From: [REDACTED]
Sent: 25 February 2025 22:36
To: planninginfo
Subject: DM/25/0014 and DM/25/0015

These comments follow review of the various documents associated with the planning application DM/25/0014 and DM/25/0015. Both numbers are noted as the same application site and so comments below apply to both numbers.

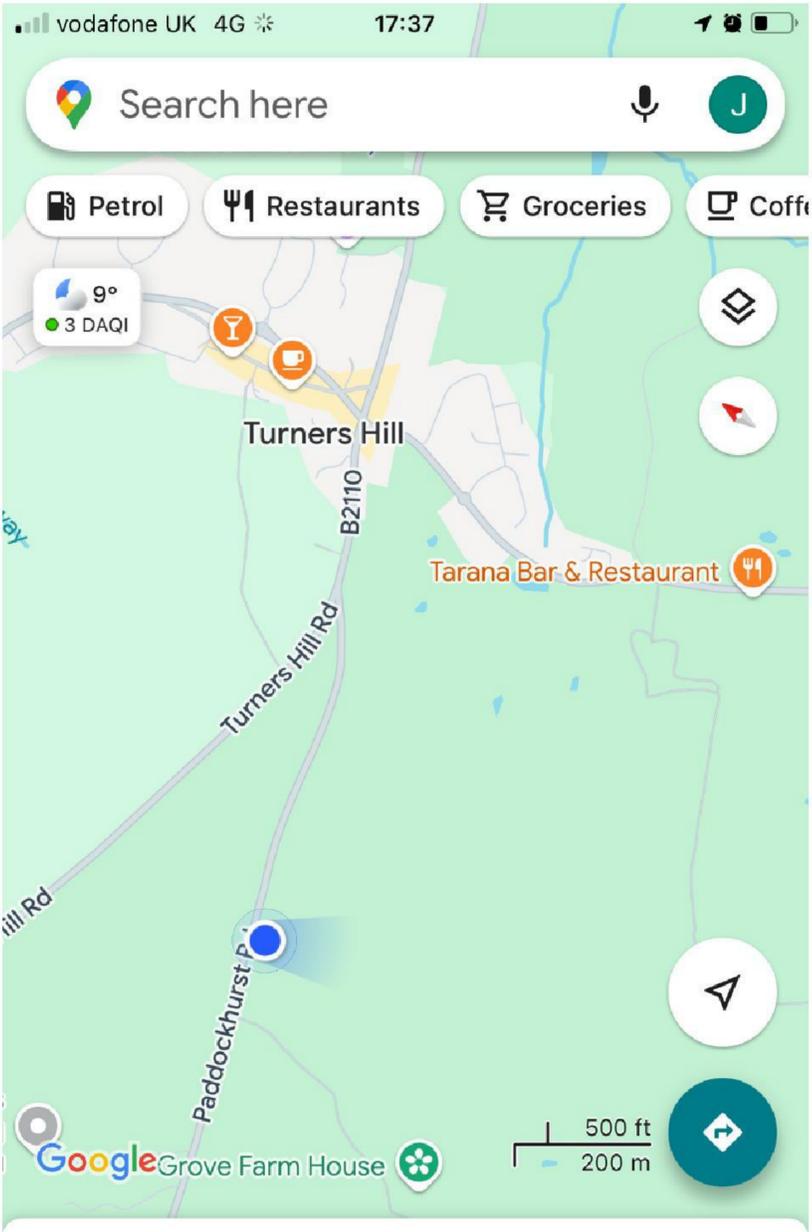
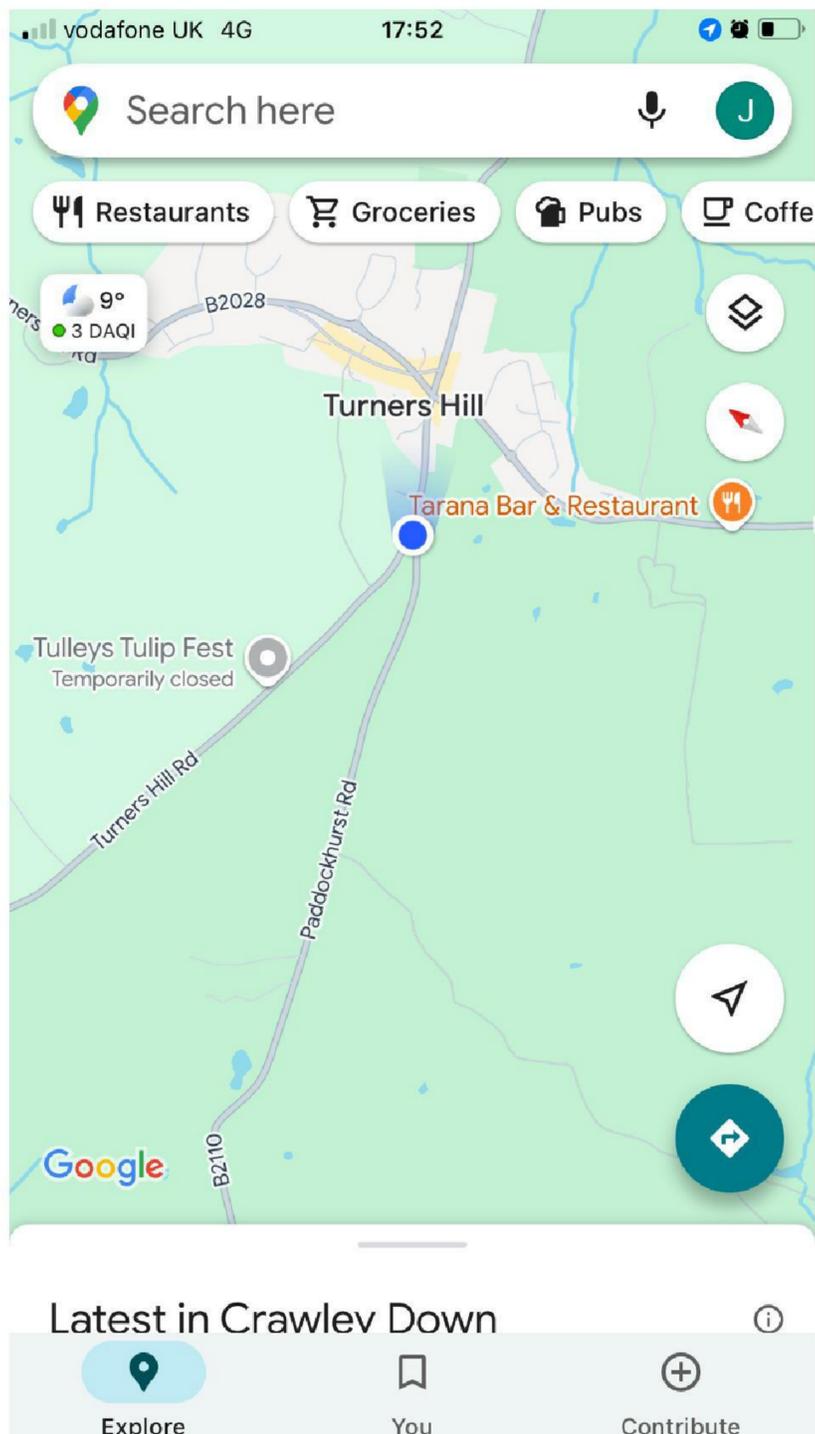
The TA references a Leeds development where, at appeal, a +50% delay in junction queuing was not considered severe. This case is 9 years old, in West Yorkshire and involved a 97 second queue time increasing to 151 seconds. Evidence of local queue times being 15 minutes to travel 500m:

At 5.30pm on 24/02/25, , I queued in traffic on the approach to Turners Hill junction along Church Road. The queue began just before this map location of our car was taken in first screenshot below. Shown taken at 17.37 (time shown at top).

The second screenshot taken 15 minutes later we had just progressed to the side road before the village houses of Turners Hill start. Time shown as 17:52 to queue approximately

It is not realistic this junction is not considered over capacity, and that 100s of additional residents needing 000s of journeys to schools, doctors, work will not make this junction use 'severe'.

With the West Sussex Transport Strategy 'severe' criteria of +3% RFC, using the average car length of 5m, the 15min queue to cover 500m example I documented above on 24/03/25 and a reasonable proportion of new sites' residents to travel this route, the impact on this junction can only be classed as severe.

“East Grinstead is 20minutes by bus”

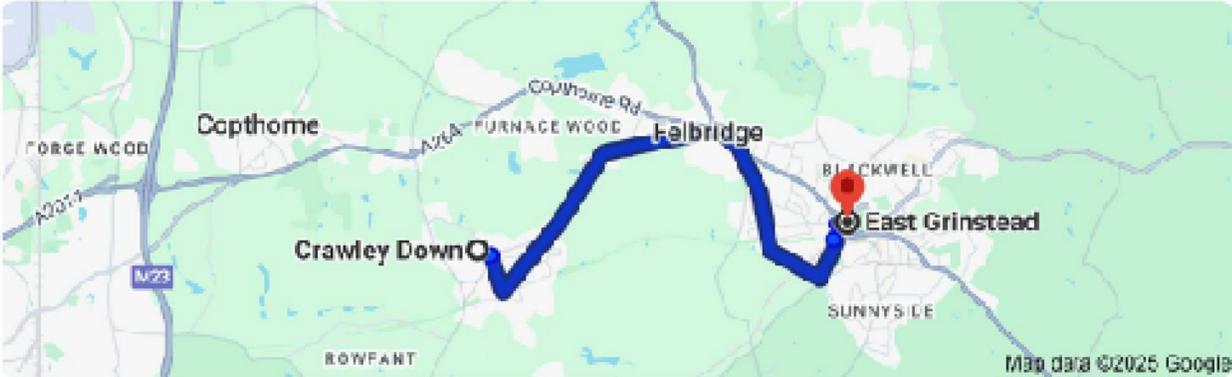
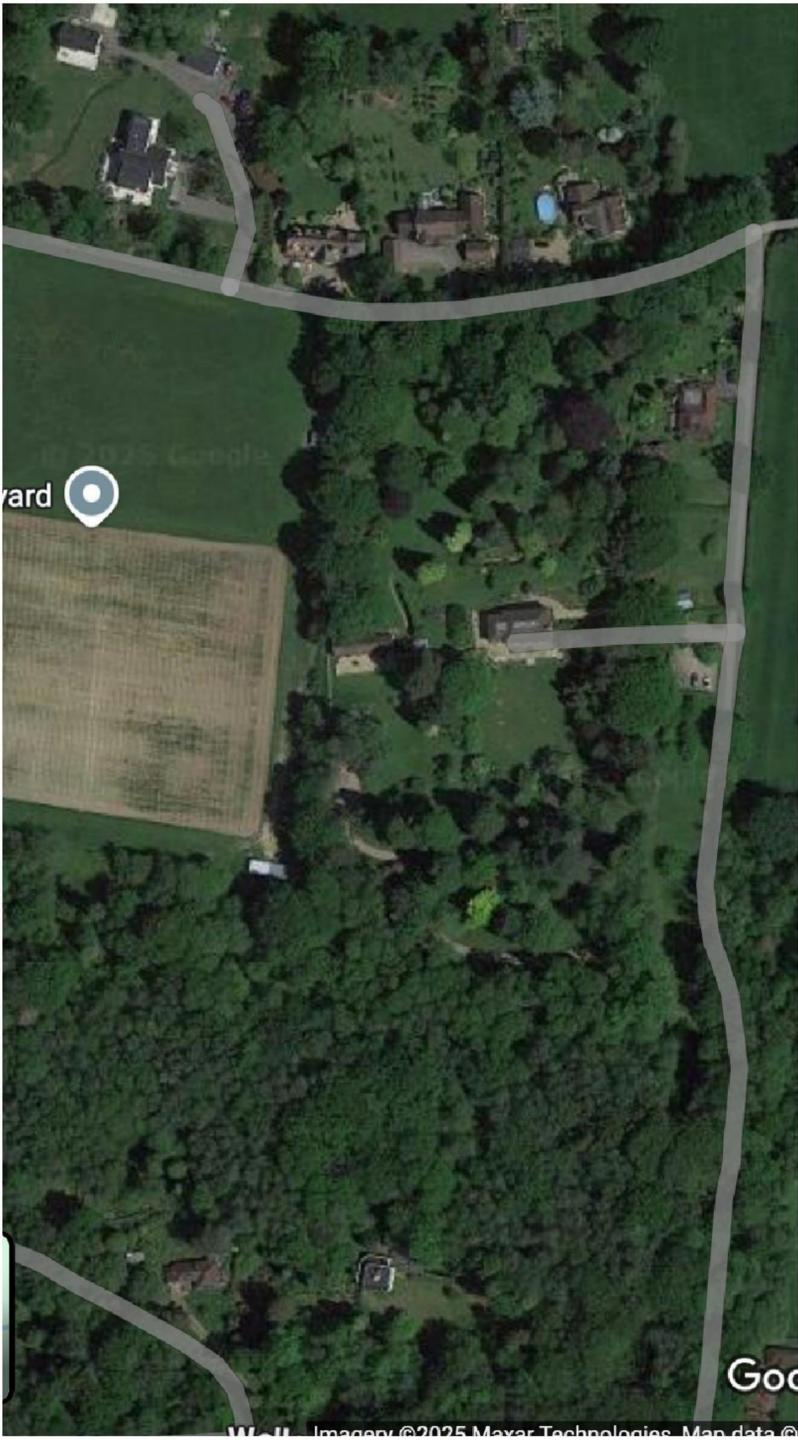
See time estimates from bus timetables, none of which are 20 minutes. Only 1 out of 5 could be rounded down to 20 minutes. M

This misinformation raises the question how much other misinformation in these documents.
